# REPLACEMENT OF THE WATER PUMP 65128 IN 65131

TECHNICAL INFO NO. 1096

**Mercedes Benz** | E-Klasse (W212)  
C-Klasse (W203 / W204)

M 271.952  
M 271.860 / M 271.820

Fig. 1: Water pump 65131

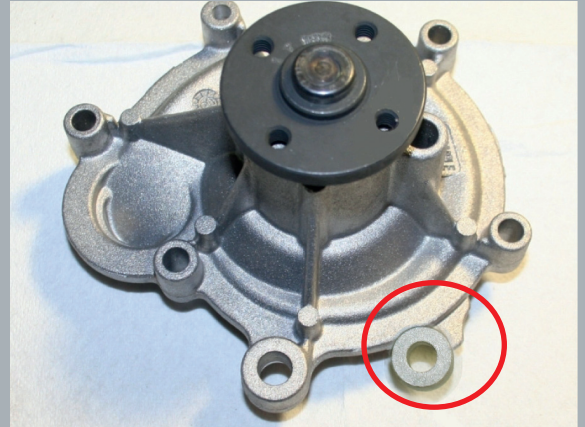
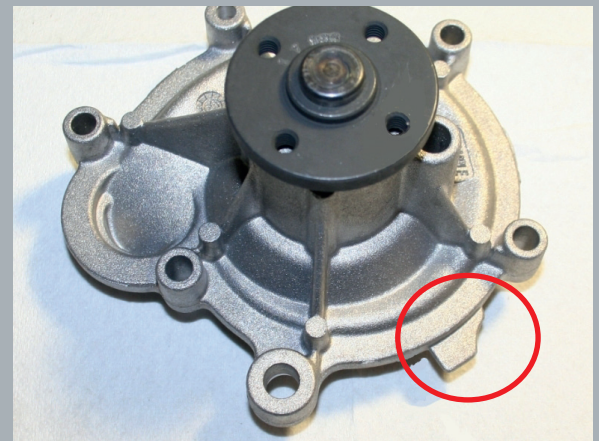
The water pump 65131 can be used to replace the water pump 65128; however the water pump 65128 **CANNOT** be used to replace the water pump 65131.

On the OE side, the water pump 65128 was replaced by the water pump 65131.

There is an extra attachment borehole in the casing of the water pump 65131.
